# Heavy Vehicle Local Road Report Clyde

<b>Project Name:</b>	Sydney Metro West		
<b>Client Name:</b>	Sydney Metro		
<b>Project Address:</b>	Delta will be working at the following sites: 1. Parramatta 2. Clyde 3. Westmead		
<b>Project Description/Scope:</b>	DELTA Pty Ltd (DELTA) is responsible for the demolition of existing structures including removal of all hazardous materials and utility works of the Sydney Metro West Project at Clyde, Parramatta and Westmead		
<b>Prepared By:</b>	Name: [Redacted]	Signature: [Redacted]	Date: 12 <sup>th</sup> October 2021
<b>Reviewed By:</b>	Name: [Redacted]	Signature: [Redacted]	Date: 12 <sup>th</sup> October 2021
<b>Authorised By (Project Director):</b>	Name: [Redacted]	Signature: [Redacted]	Date: 12 <sup>th</sup> October 2021

This Heavy Vehicle Local Road report (HVLR) has been developed to address the requirements of the Ministerial Conditions of Approval related to the Critical State Significant Infrastructure of Sydney Metro West.

DRAWING No: **CLY-SPA-04-ST**

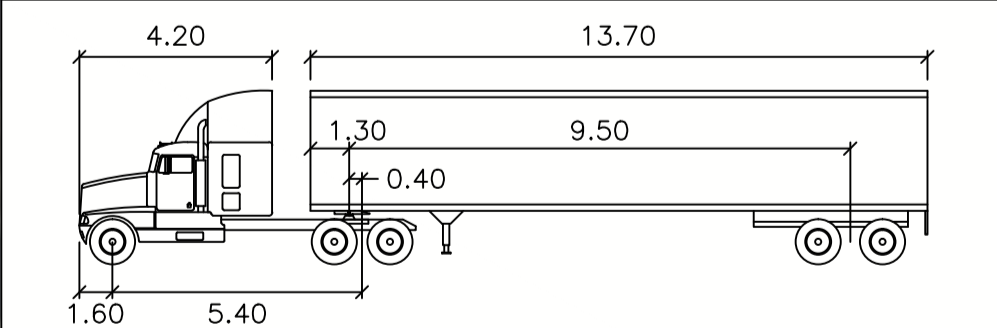
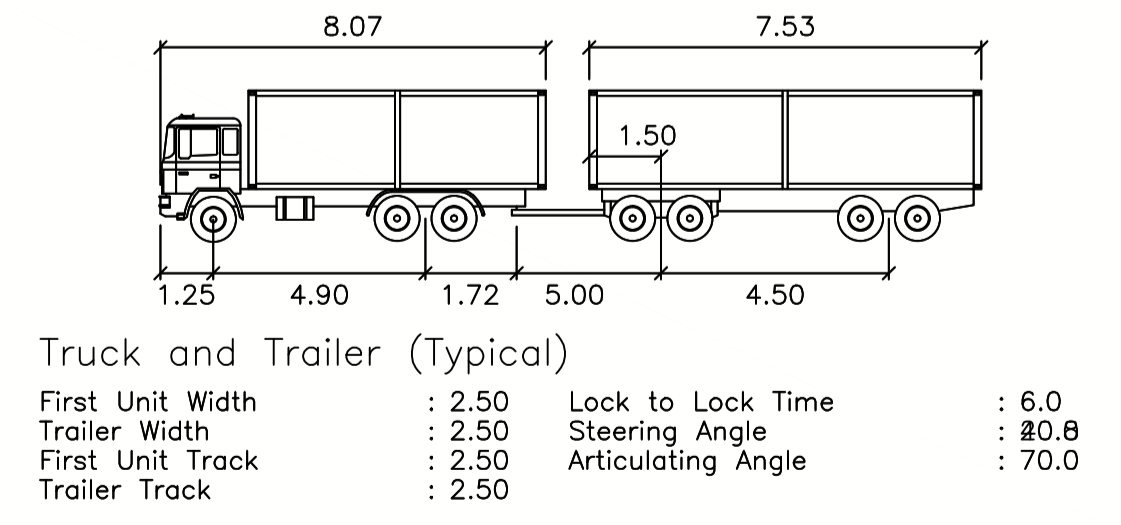
26.01	20/09/2021	DLT	[REDACTED]	SMWSDDS-DLT-CLJ-TF-PLN-000031	Appendix B, Dwg No CLY-SPA-04	n/a	The semi trailer swept path is now included and shown that this movement is not possible without civil works.	Observation	Y
							[REDACTED]	SMWSDDS-DLT-CLJ-TF-PLN-000031	Appendix B, Dwg No CLY-SPA-04	n/a		Observation	Y
				27	8/09/2021	PAR	[REDACTED]	SMWSDDS-DLT-CLJ-TF-PLN-000031	-	n/a	It has been proposed that the applicant will provide a dilapidation report for affected roads. Once the project is completed, they will either rectify any damage or pay for its repair. This is fine, however, there is no information on the regime of regular road inspections and who will be doing maintenance during the project.	Observation	Y
							[REDACTED]	SMWSDDS-DLT-CLJ-TF-PLN-000031	-	n/a		Observation	Y
